**DATE:** 10.31.2017  
**TO:** ProTrak  
**FROM:** Mitesh Baxi  
Traffic Engineering

■ **PEACE BAPTIST CHURCH [TRC Plan Review]**

☞ Initial Review Note ☞

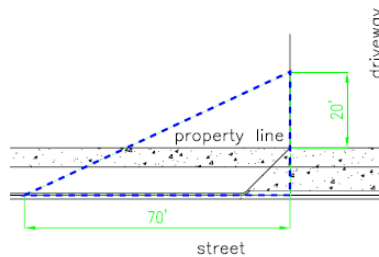
- The site is within 500’ of a Traffic Signals. Revise all sheets to accurately illustrate the existing conditions on and surrounding this parcel. Show all adjacent traffic signs, lane configurations, traffic control devices and pavement markings for the driveway intersection with Military Cutoff Road. Additionally, also include these details for intersection of Military Cutoff Road & Arboretum Drive on the site inventory plan. Please refer to the Technical Standards and Specifications Manual (link is below) Ch. VII C.1.a.2.for specific information and distance requirements. Contact Traffic Engineering at 341-7888 if you need assistance locating these elements.
- If pavement markings on site have weathered to the point they are not in accordance with the MUTCD standard of maintenance, must be maintained by the developer accordingly.
